**WATTS BAR NUCLEAR PLANT (WBN) UNIT 1 – CORE OPERATING LIMITS  
REPORT (COLR) FOR CYCLE 7, REVISION 5**

The purpose of this letter is to provide Revision 5 of the Cycle 7 COLR in accordance with WBN Technical Specification 5.9.5.d. Revision 5 revises the axial flux difference (AFD) limit and the W(z) values. This revision was effective as of June 28, 2006.

**Watts Bar Nuclear Plant Unit 1  
Cycle 7 Core Operating Limits Report, Revision 5**

Revision 5

Figure 3  
Axial Flux Difference Acceptable Operation Limits as a  
Function of Rated Thermal Power (RAOC)

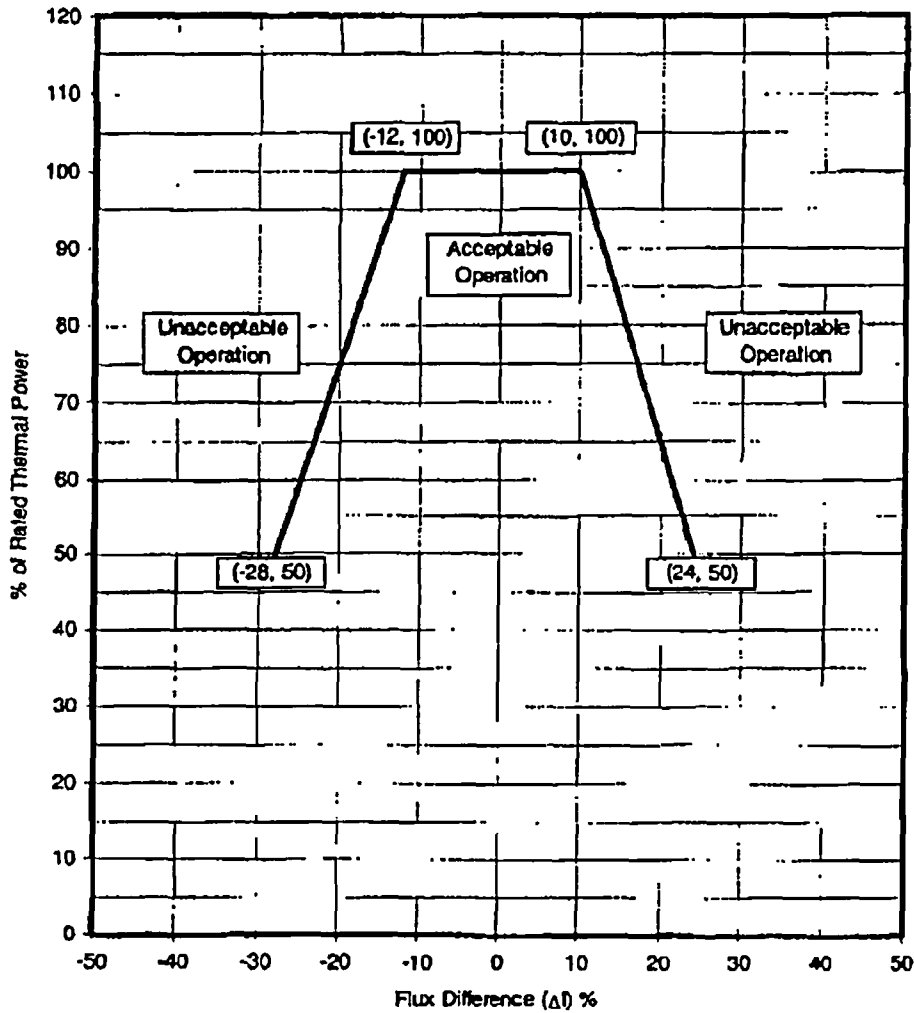
Revision	Date of PORC Approval	PORC Meeting Number	Affected Pages	Reason for Revision
0	3/11/05	4073	All	Initial issue
1	3/18/05	4075	All	Revised to remove cycle 7 restriction to mode 6
2	5/31/05	4089	1, 9 - 12	Revised maximum W(z) values
3	9/19/05	4107	1, 9 - 12	Revised maximum W(z) values
4	3/13/06	4127	1, 10 - 12	Revised maximum W(z) values
5	<i>6/28/06</i>	<i>4144</i>	1, 4, 8, 12	Revised AFD Limit and W(z) values

2.6.1 The AFD limits for Cycle 7 are provided in Figure 3.
